DART SERVICE INSTRUCTION

**TO AMEND IIN-D139-816 REV. D OR SUBSEQUENT
AND ICA-D139-816 REV. 3 OR SUBSEQUENT**

The purpose of this Dart Service Instruction (DSI) is to provide instructions to install the D5078-1 Bracket to support the Overhead Connector for D139-811-011 Interior Ceiling Panel Kit.

Figure 1. - LH Side Overhead Panel

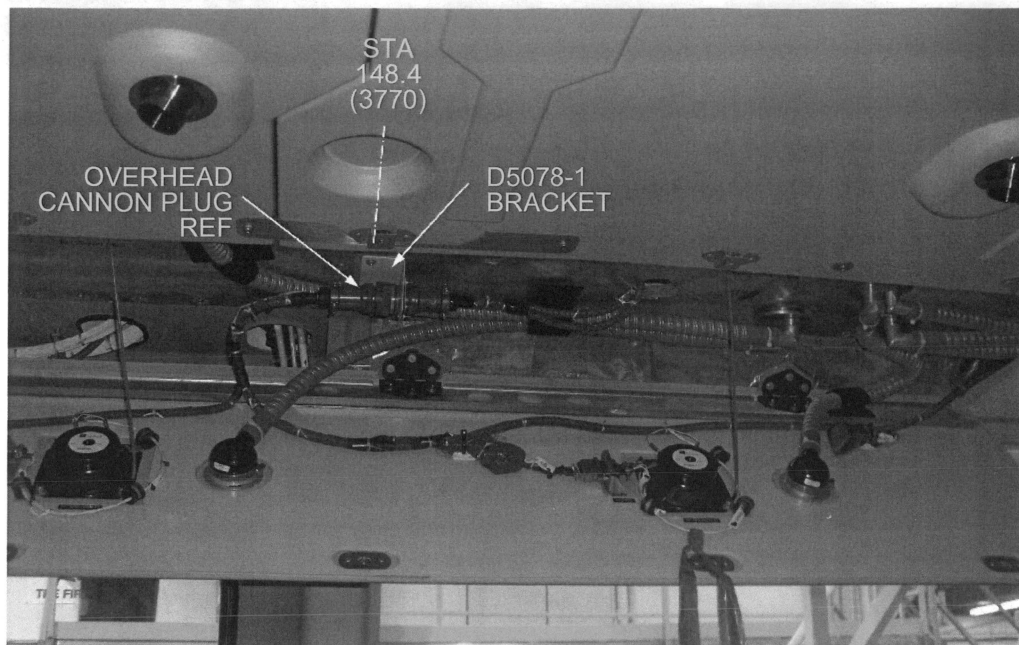
- 2.1 Position the D5078-1 Bracket on the LH side of the cabin overhead by temporarily removing 2x MS27039-1 screws as shown in Figure 1. Transfer 2x $\varnothing 0.204$ " (#6 drill) holes from airframe to the D5078-1 Bracket. Deburr and touch-up holes with MIL-P-85582 or MIL-P-23377 primer.
- 2.2 Install D5078-1 Bracket using existing 2x MS27039-1 screws and washers as shown in Figure 1.
- 2.3 Install overhead cannon plug in the D5078-1 Bracket using existing NAS1801/1802 screws and existing AS85049/95-20A-A Perimeter Mounting Flange as shown in Figure 2.
- 2.4 Reconnect wire harness to overhead cannon plug as shown in Figure 2.
